# UNITED STATES PATENT AND TRADEMARK OFFICE

APPLICATION NO.	FILING DATE	FIRST NAMED INVENTOR	ATTORNEY DOCKET NO.	CONFIRMATION NO.
10/814,652	04/01/2004	Hirobumi Shirataki	XA-10075	5968
181	7590	07/27/2005	EXAMINER	
MILES & STOCKBRIDGE PC 1751 PINNACLE DRIVE SUITE 500 MCLEAN, VA 22102-3833			RODRIGUEZ, SAUL	
		ART UNIT		PAPER NUMBER
		3681

<b>Office Action Summary</b>	<b>Application No.</b>	<b>Applicant(s)</b>	
	10/814,652	SHIRATAKI ET AL.	
	<b>Examiner</b>	<b>Art Unit</b>	
	Saúl J. Rodríguez	3681

This is a first office action on the merits of patent application S. N. 10/814,652.

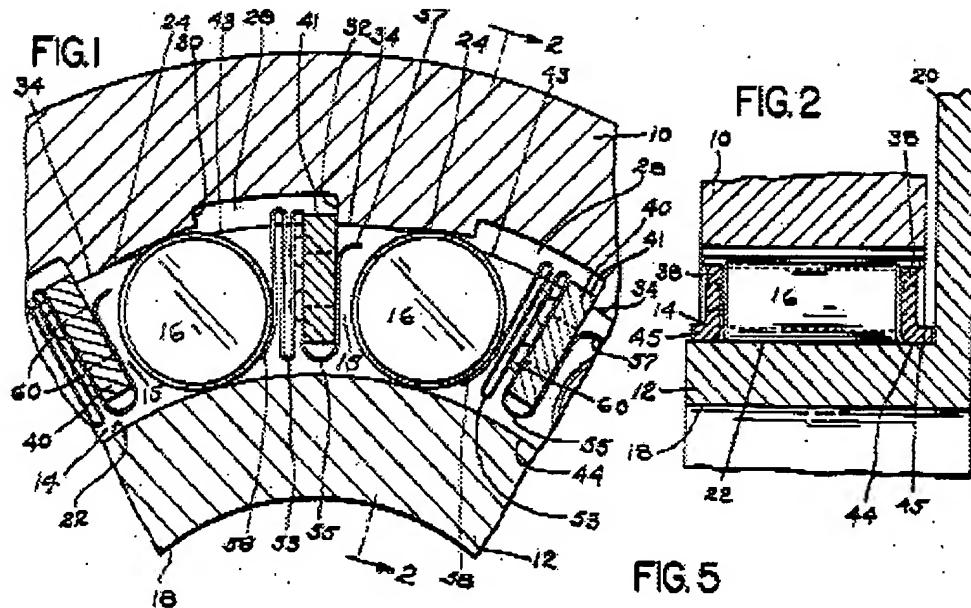
Claims 1-10, as understood, are rejected under 35 U.S.C. 102(b) as being anticipated by Sauzedde et al. ('053).

Sauzedde et al. discloses a one-way apparatus comprising outer and inner races (10, 12), cam surfaces (24), a cylindrical surface (22), torque transmission members (16), biasing means or accordion springs (53), block bearing members (45), a rotatable retainer (14), a retaining groove (28), a latch piece (24), and a retaining column (40).
